Safety Recall Notice 18V-794

Terex Utilities	
SAFETY NOTICE	SN-669

Models Affected: Digger Derricks

SUBJECT: Pole Guide Bar 450543

Figure 1 - Example of a crack

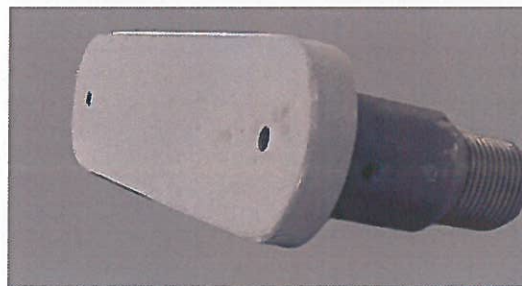
1. Inspect for cracked welds as shown in figure 1 below. If cracks are found, remove the part from service. Contact Terex Utilities as noted below.
2. Inspect the digger derrick pole guide bar 450543 by comparing to the pictures below. If the bar has a grease zerk on the bar side and flush with the surface it is subject to this bulletin.

Inspect for any cracks:

Zerk flush to top surface

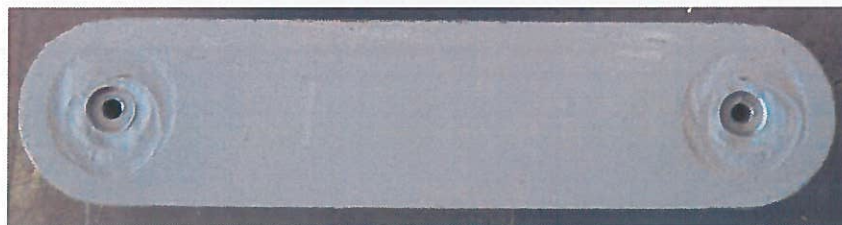
1. The grease zerk will be on the upper side above the pole guide arms and the surface is flat.
2. The top surface of the bar will be nearly flat with a milled counterbore (recessed area) for the grease zerk.

Bars which are involved in bulletin:

Terex will provide a replacement guide bar (Z1523).

Reworked stamped R, B, or four stamped letters

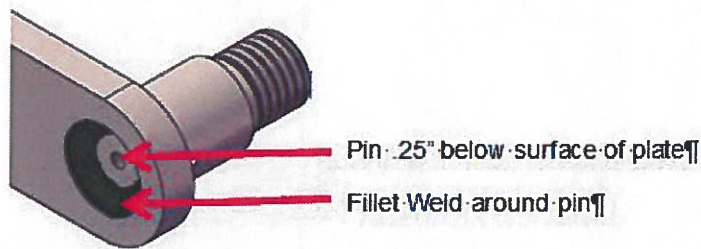
1. Weldments with one to four stamped marks on the top of the bar are older production or have been repaired.

Fillet weld around recessed pin

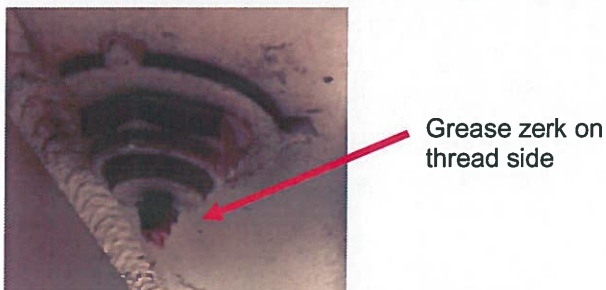
2. Weldments with a fillet weld around the pin and the top of the pin recessed below the surface of the bar.
